DEP Homes - Jackson & 26th | #3024841 | Design Review Recommendation

Design Review Recommendation

2524 South Jackson Street | DPD #3024841 August 9, 2017

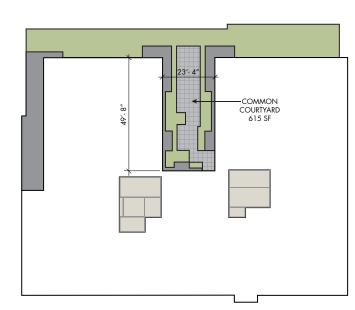
a. The Board approved the location of the front entry at the west edge of the site and the recessed

The front entry location at the west edge of the site allows the retail to occupy the dominant location at the corner of 26th and Jackson, and the residential entry to have its own identity separate from the retail area. The entry is recessed and has a distinctive canopy.

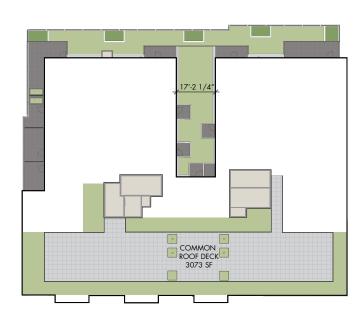
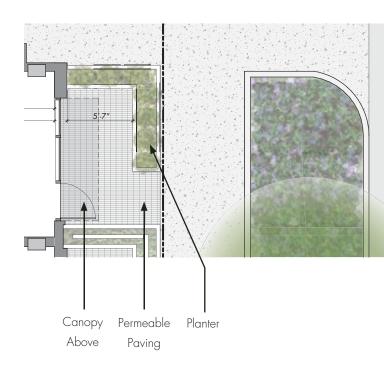
b. The Board directed the applicant to make sure that the Live Work units are designed to meet the street as commercial spaces with landscaping and paving options to focus the eye on the various commercial entries. Canopies should highlight the commercial uses at street level. (PL3 C1,2)

The live work units meet the street as commercial spaces with a generous entry patio unique to each unit that is wrapped with a planter. Large, tall windows bring attention to the units and make them transparent to the street. Unique paving serves as a welcome to the entry.

3. Façade Design:

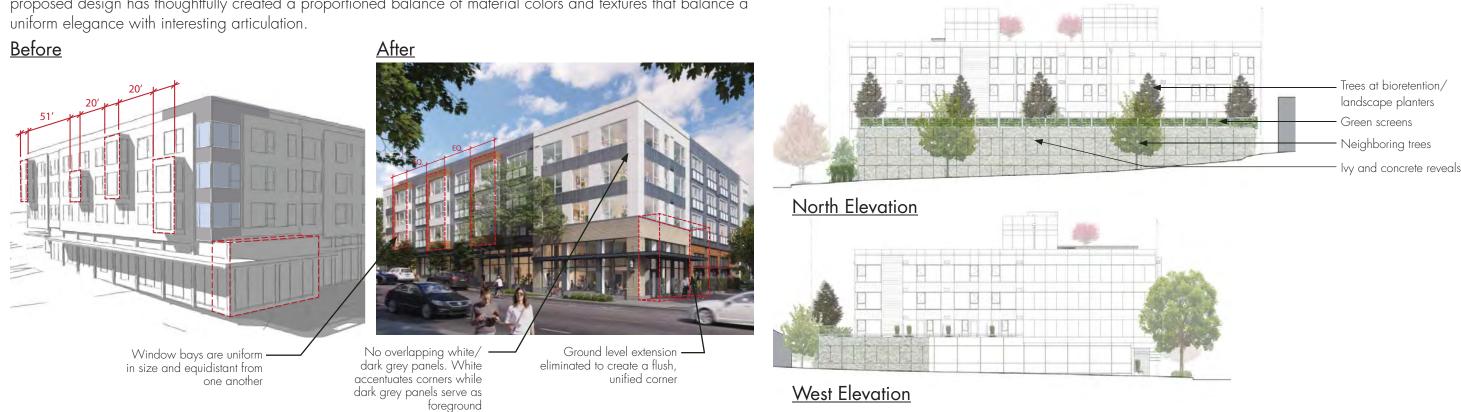
a. The Board was not in favor of large overhanging bays or boxes on the facades. They directed the applicant to a. The Board directed the applicant to specify high quality materials throughout. (DC4 A, DC2 D) design a uniform and unified façade design that is simple and elegant. They noted that the façade should have balconies and secondary architectural elements to create small shadow lines, but the applicant needs to avoid a The proposed materials include a mix of metal panel, fiber cement panel, and laminated wood panel. boxy look with layer upon layer of boxes and frames. The Board discouraged bay window pop outs. (DC2B1)

A unified design that is simple and elegant is proposed. The facades address the different conditions on both Jackson and 26th and come together as a unified whole. The strong retail corner is emphasized with a brick base and upper levels that are framed in white. The 26th Avenue facade meets the quiet residential street with live-work units that have patios that spill out to the sidewalk, and a residential facade above that is simple and elegant with large windows. The Jackson facade is articulated with elements that create a lively interaction with the activity on the street: alternating facade projections have corner windows that look down the street to the activity to the east, and between the alternating projections, units have juliette balconies. Although there are projections, they will not be perceived as projections from the sidewalk below because of a canopy overhang above the sidewalk. However, the projections will be viewed from a distance as an orderly rythmic articulation on the building face.

Note that the design has avoided the boxy, random bay pop outs that were shown schematically in the EDG presentation. The design has also eliminated the layer upon layer that was in that EDG sketch. Instead, the proposed design has thoughtfully created a proportioned balance of material colors and textures that balance a 4. Materials:

Departure Requests

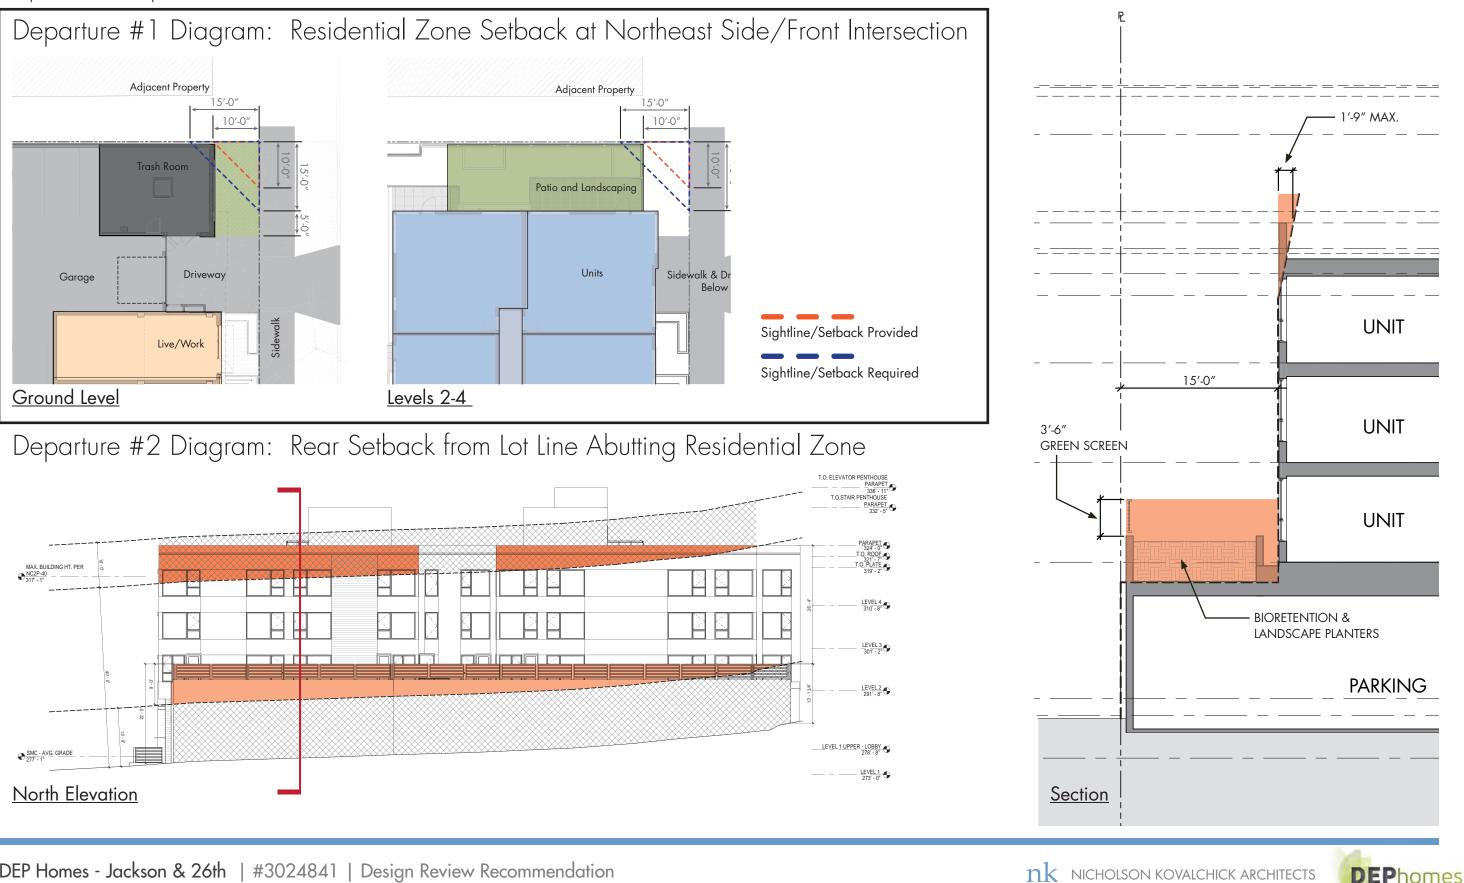
ZONING CODE	REQUIREMENTS	DEPARTURE	
Departure #1 RESIDENTIAL ZONE SETBACK AT SIDE/FRONT INTERSECTION SMC 23.47A.014	Northeast corner: A setback is required where a lot abuts the intersection of a side lot line and front lot line of a lot in a residential zone. The required setback forms a triangular area. Two sides of the triangle extend along the street lot line and side lot line 15 feet from the inter- section of the residentially zoned lot's front lot line and the side lot line abutting the residentially zoned lot. The third side connects these two sides with a diagonal line across the commercially-zoned lot.	The upper levels (2-4) meets the required setback. At the ground level, we propose a 10' deep by 20' wide landscaped recess. The proposed recess is increased from 5' deep by 20' wide from the EDF meeting increasing the landscape screening from 100 SF to 200 SF. (See diagram on next page)	At the upper levels, an even greater s adjacent residential property. At the Trash Storage and would preferably b less view of this utilitarian area. Add building to be offset from the level ab architectural interest and relief in the r Applicable Design Guidelines: PL4.C.4 Service Uses: Service entrie DC2.A.2 - Reducing percieved mass

Departure #2 REAR SETBACK FROM LOT LINE ABUTTING RESIDENTIAL	0'-0" up to a height of 13'-0" above finished grade, then 15'-0" setback required for portions of a structure from 13'-0" to 40'-0", then an additional 2'-0" of	a. Lower section: A setback of 6" is provided up to a height of 22'-0" above finished grade at the northeast corner and up to a height of 13'-2" above finished grade at the northwest corner. This	a. Lower section: The slab height for live-work units and to have high ceilir the space accessible. The additional
ZONE SMC 23.47A.014	setback for every 10'-0" above 40'-0".	 is a departure of 819 sf of wall that is 9'-0" high at the northeast corner of which 3'-6" is green screen and tapers to zero at the northwest corner. b. Middle section: A setback of 15'-0" is provided from a height of 22-0" to 40'-0" at the northeast corner and from a height of 13'-2" to 40'-0" at the northwest corner as required. The proposed design is compliant in the middle section. 	that will enhance the view for neighb view for the neighbors. The use of pla scale, and provide a privacy screen

is a departure of 635 sf of wall that ranges in height from 9'-0" at the northeast corner, and tapers to zero at the northwest corner. The top of Level 4 and the parapet encroaches a maximum of 1'-9" at the northeast corner. (See diagram on next page)	Applicable Design Guidelines: CS1.D.1 - Plants and Habitat CS2.D.1 - Height Bulk and Scale DC2.A.2 - Reducing perceived mass
